NOTICE OF DECISION

DR121-0006 – 601 S Blaine Street – Zone Holdings ADU

STAFF REPORT
DR121-0006 – 601 S Blaine Street – Zone Holdings ADU

REQUEST: Approval of an ADU

1 SITE PLAN
SCALE: 1"=20'

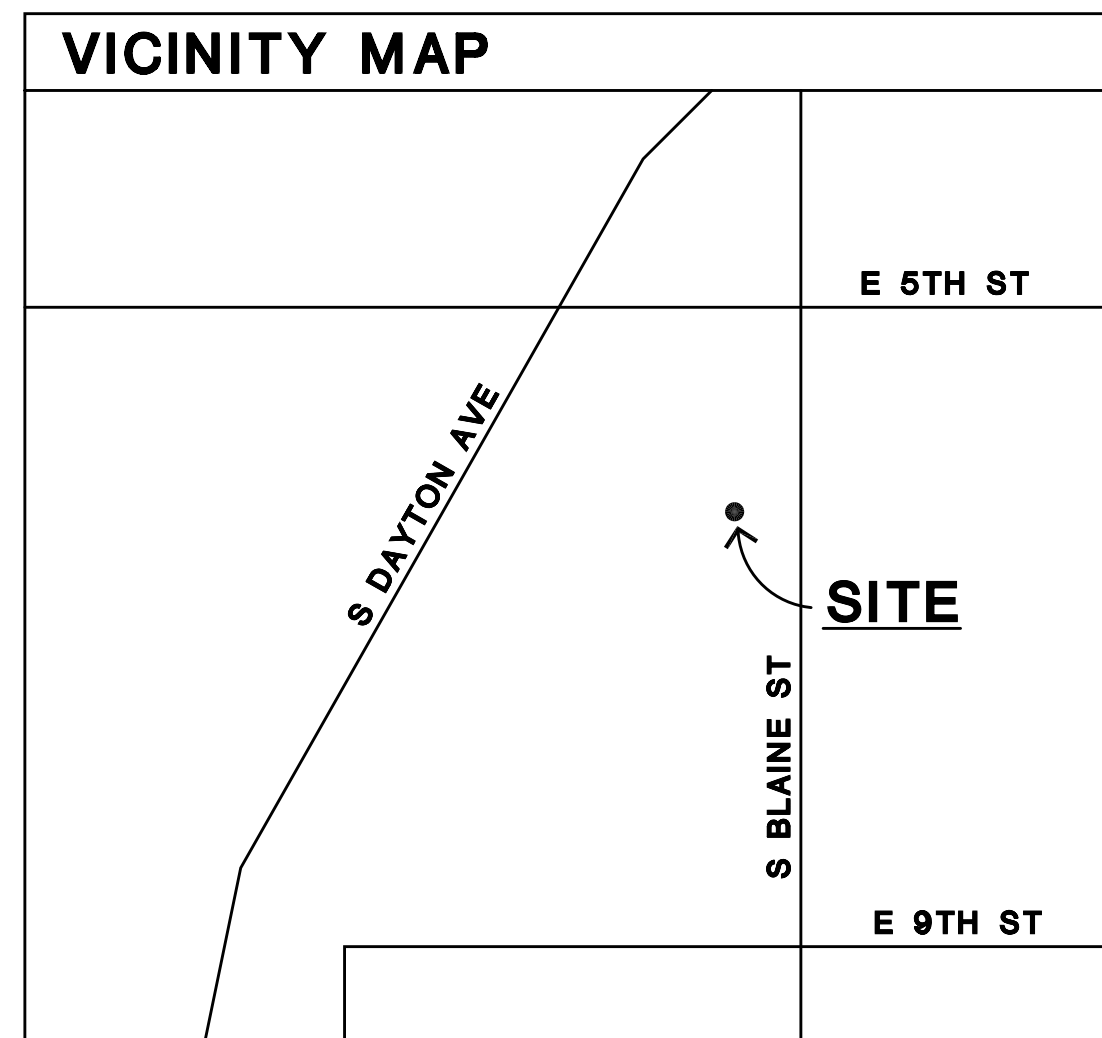
Finding: According to the applicant's site plan, the subject property is approximately 1.25 acres or 54,450 square feet, which exceeds the 3,000 square foot minimum lot area for R-3 zoned property. Additionally, the subject property is an existing lot of record. The applicant is not proposing a partition or subdivision as part of this application. This criterion is met because the subject property is a pre-existing tax lot that meets the minimum R-3 lot size of 3,000 square feet.

Finding: The subject property is zoned R-3, which allows a maximum lot coverage of 50%. Maximum allowable parking coverage is 30% and a combined lot and parking coverage of up to 70% is permitted. Lot coverage calculations must include the existing single-family dwelling, detached garage and detached shop building. The application material did not provide the existing and proposed lot and parking coverage calculations as defined in the NMC. The applicant has stated that the existing building footprints will not be increased. Because the applicant did not provide lot and parking coverage calculations, with the building permit submittal, the applicant will provide lot, parking and combined lot and parking coverage calculations that demonstrate compliance with NMC 15.405.040(B). These criteria will be met with the adherence to the aforementioned condition of approval.

Finding: The applicant's plans illustrate an existing sidewalk across the shared access drive on the property frontage along S Blaine Street. Because it is not clear if the existing sidewalk along the property frontage is in good condition, the applicant will be required to replace any sidewalk panels not meeting ADA requirements along the subject property's S Blaine Street frontage. Review of existing sidewalk panels and confirmation of any panels to be replaced is to occur as part of the building permit review process for construction of the ADU. This criterion will be met with the adherence to the aforementioned condition of approval.

1. With the building permit submittal, the applicant will provide lot, parking and combined lot and parking coverage calculations that demonstrate compliance with NMC 15.405.040(B).

2. The applicant will be required to replace any sidewalk panels not meeting ADA requirements along the subject property's S Blaine Street frontage. Review of existing sidewalk panels and confirmation of any panels to be replaced is to occur as part of the building permit review process for construction of the ADU.

1 EAST ELEVATION (FRONT)
 SCALE: 1/4" = 1'-0"

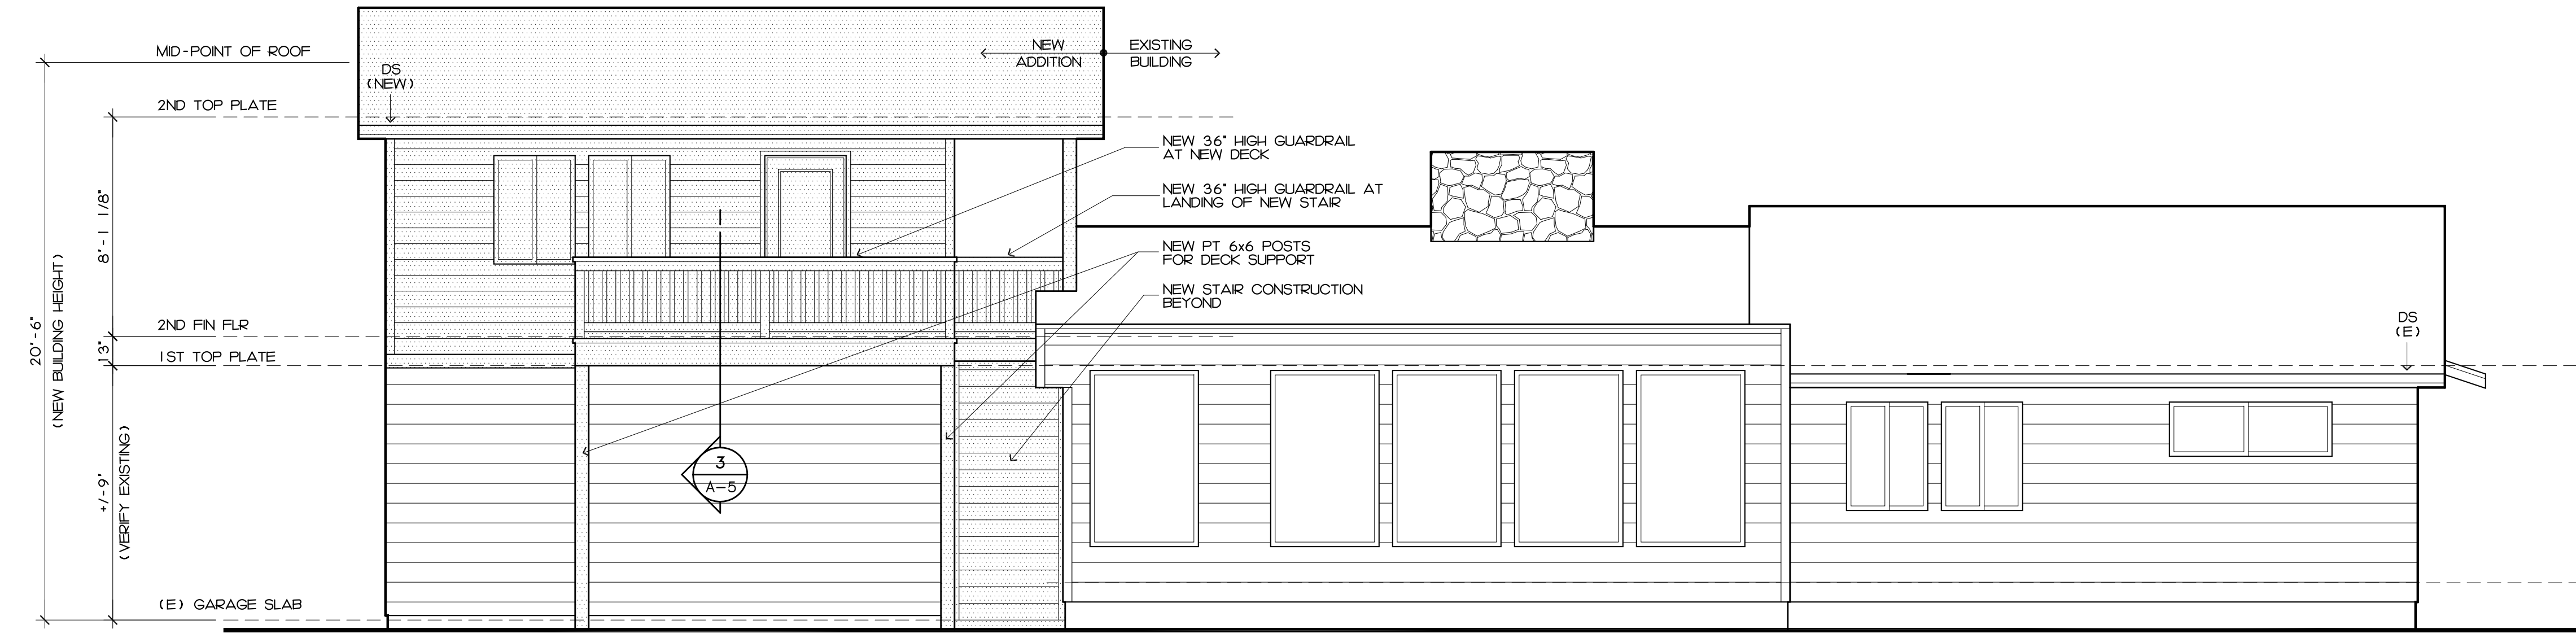
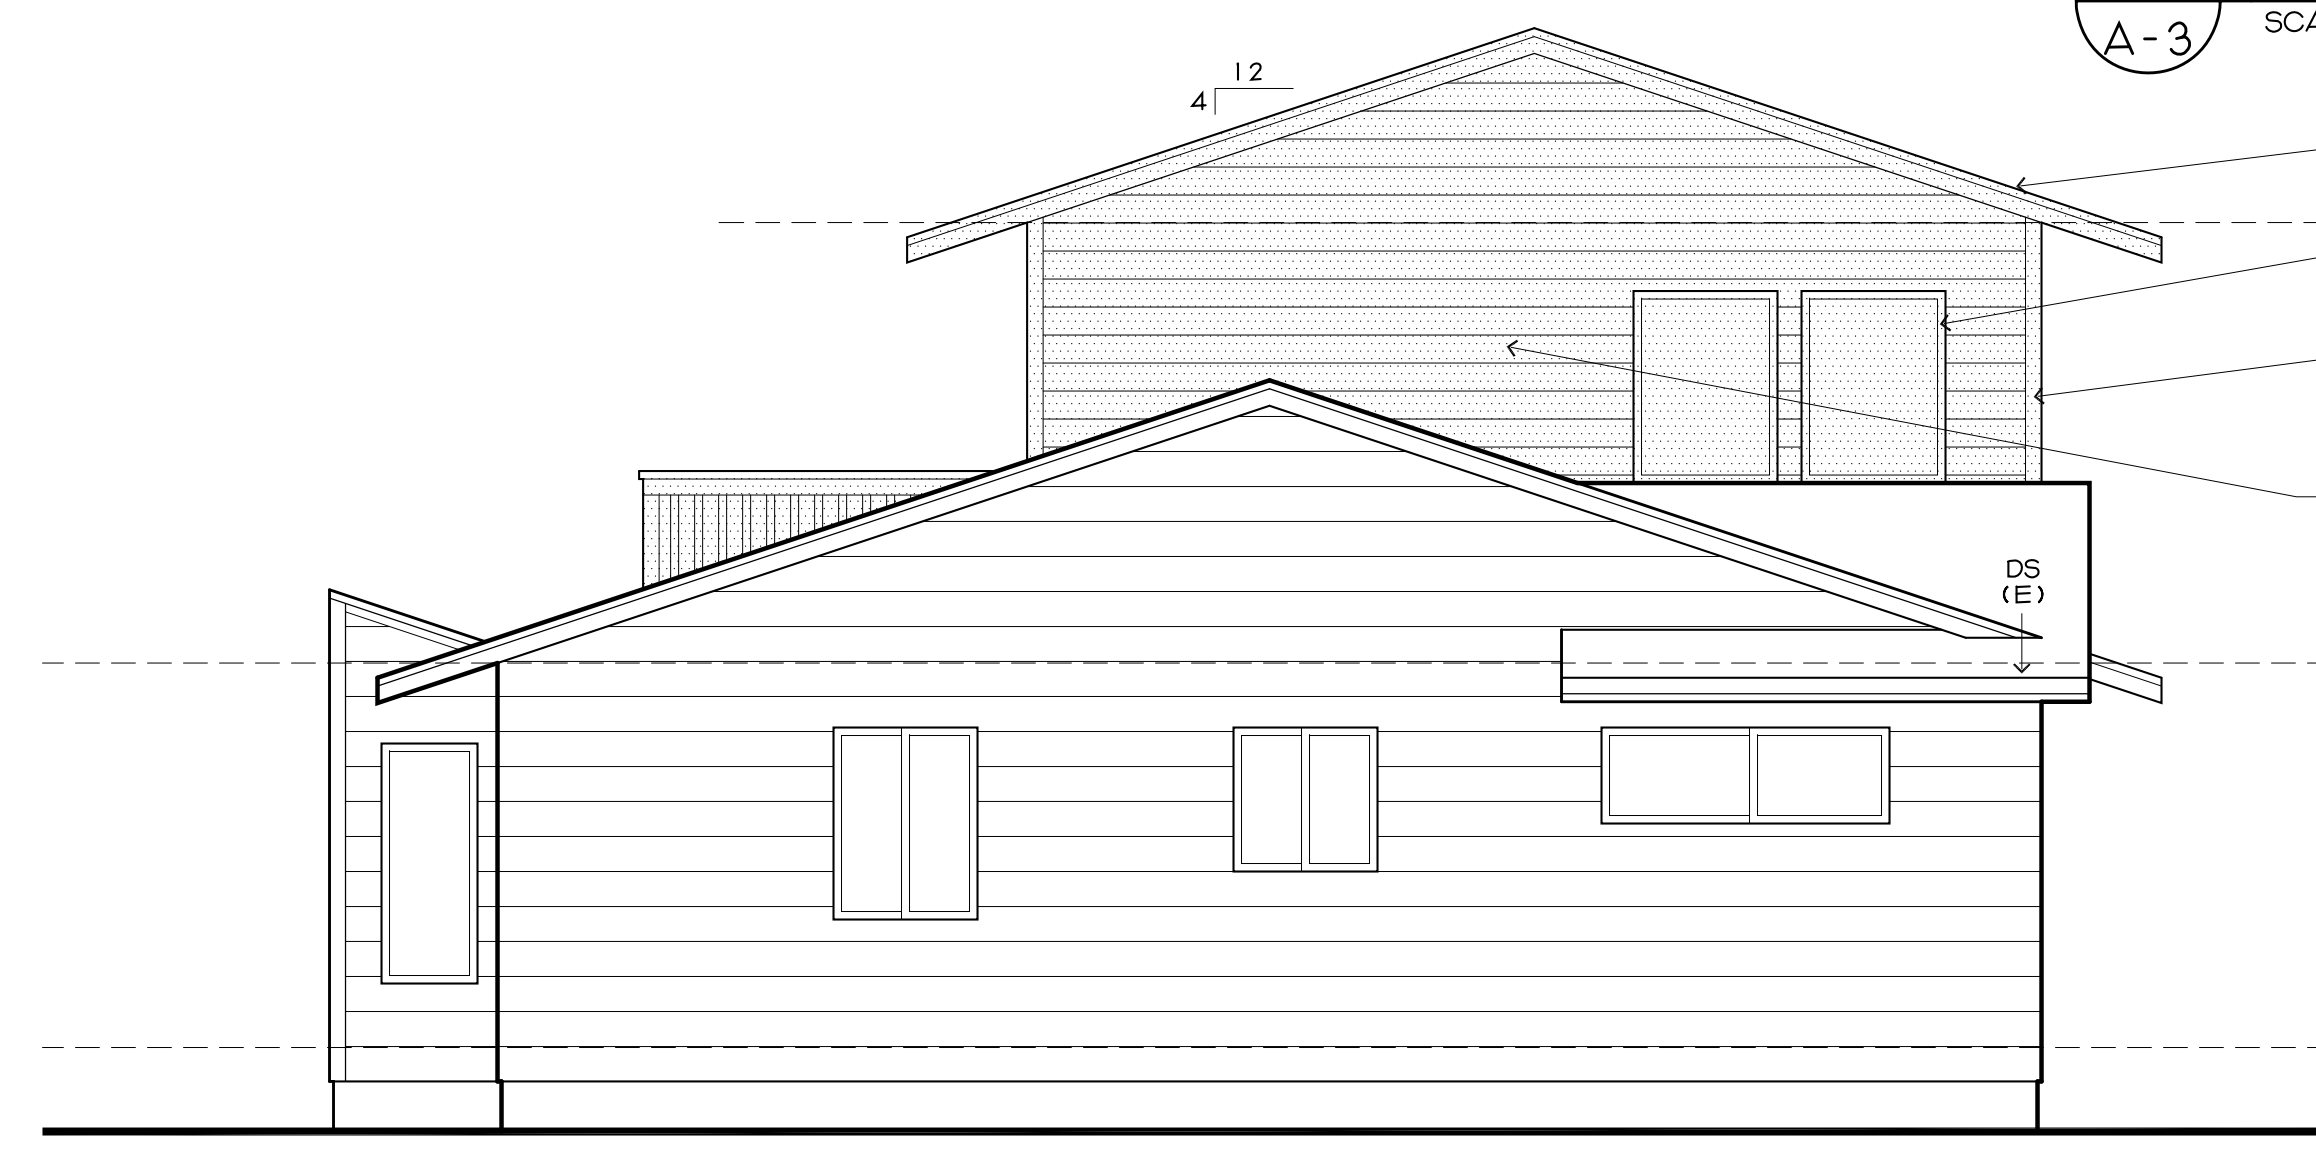
Finding: The ADU will be constructed above the existing detached garage and the building footprint will not be expanded. The total square footage of the ADU will be 441 square feet. The applicant's building elevation plan illustrates that the proposed building height will be 20 feet 6 inches, which is less than the maximum allowable building height of 24 feet for up to 800 square feet of an accessory building. This criterion is met.
